VILLAGE OF DOWNERS GROVE
Report for the Village Council Meeting
6/7/2016

SUBJECT:	SUBMITTED BY:
Preliminary Plat of Subdivision - 5527 - 5531 Fairmount Avenue	Stan Popovich, AICP Director of Community Development

**VILLAGE OF DOWNERS GROVE
REPORT FOR THE PLAN COMMISSION
MAY 2, 2016 AGENDA**

SUBJECT:	TYPE:	SUBMITTED BY:
16-PLC-0020 5527-5531 Fairmount Avenue	Preliminary Plat of Subdivision	Scott Williams Planner

PRELIMINARY PLAT OF SUBDIVISION
RESUBDIVISION

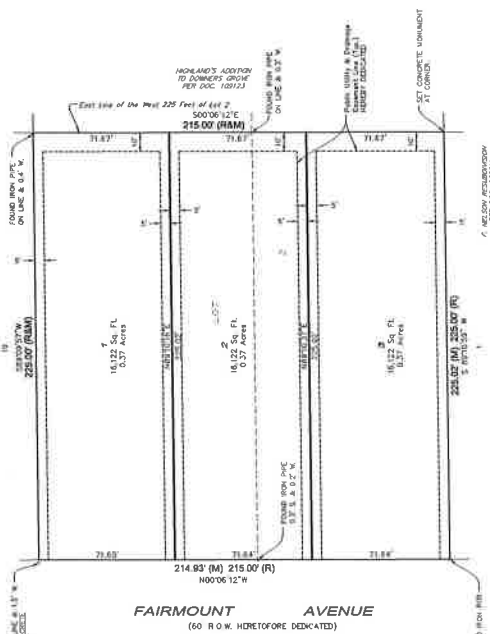
The three residential lots will not meet the minimum lot width dimension requirements outlined in Section 20.301 of the Village's Subdivision Ordinance. The proposed lot dimensions are specified in the table below:

Three lot width exceptions are requested to reduce the required lot widths from 75-feet to approximately 71.65 feet for Lots 1 through 3. The reduction of the required lot width allows the construction of three new single family homes, but there are no required public improvements or unique circumstances that would cause the reduction in the lot width.

The proposed Final Plat of Subdivision to subdivide the existing two parcels into three residential lots does not meet the lot width standards of Sections 20.301 Subdivision Ordinance and Section 2.030 of the Zoning Ordinance. The proposed subdivision meets the minimum lot area requirements of Sections 20.301 of the Subdivision Ordinance and Section 2.030 of the Zoning Ordinance

The petitioner is requesting an exception for three lots to permit 71.64 & 71.65 lot widths where a minimum of 75-feet is required. The petitioner's difficulty is that the subject properties are not wide enough to establish three 75-foot wide lots per the Subdivision and Zoning Ordinances. The standards of approval for the three requested lot width exceptions are outlined below.

1. The Final Plat of Subdivision shall substantially conform to the Preliminary Plat of Subdivision prepared by Professional Land Surveying, Inc. dated 10-21-2015, last revised on 4/4/16.
2. Park and school donations must be paid prior to approval of a Final Plat of Subdivision.
